WORKSHOP AGENDA

Planning Commission

Item #: 3. Site Plan – Smoke Club 13 – New Building of 2,759 Square Feet on 0.42 Acres. Requested by Dean Design Group. Property located at 5234 Murfreesboro Road (Tax Map 15M, Group C, Parcel 6). C-2 (Highway Service) Zoning District. Property owned by Smoke Club 13, LLC.

Staff Comments / Technical Items:

2 CONSTRUCTION ENTRANCE
SCALE: N.T.S.

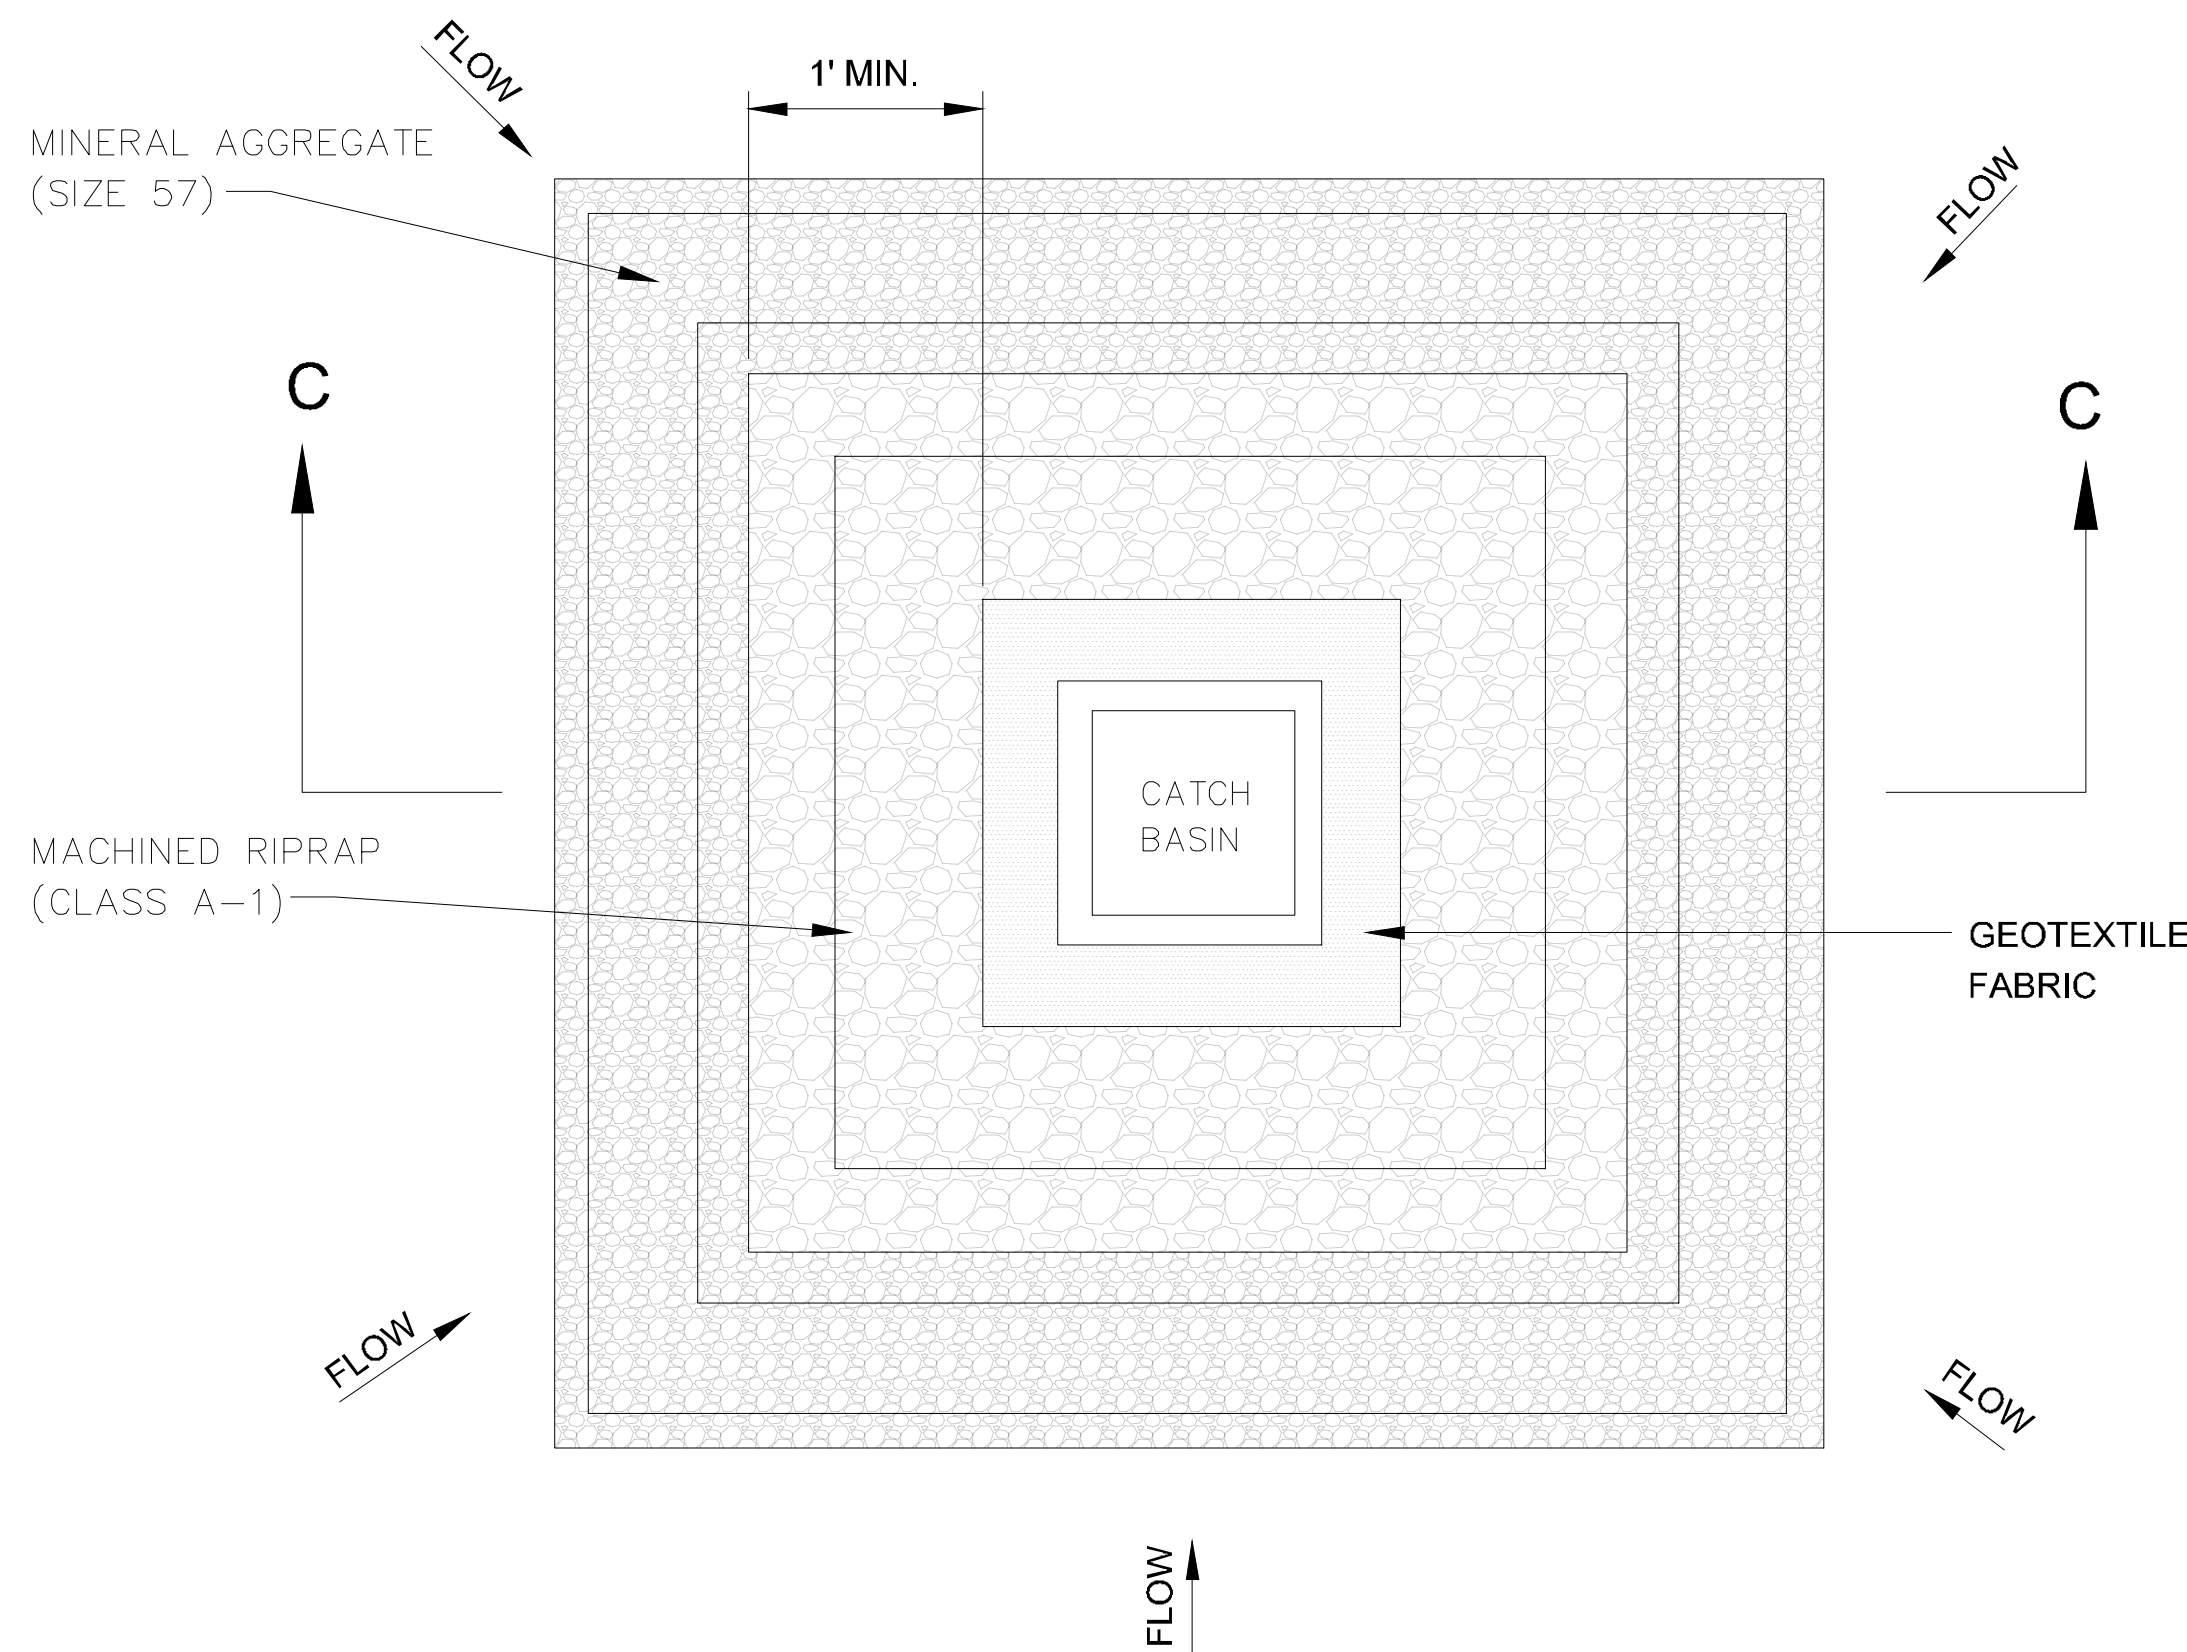
5. (Sheet C-7.3) Modify detail 2 "Construction Entrance" to account for the fact that the entrance is shown placed on top of existing asphalt.
6. (Sheet C-6.1) The dumpster screen is proposed to be exposed CMU with a wooden gate. The Planning Commission will review that proposal against requirements of the Murfreesboro Road Overlay District.
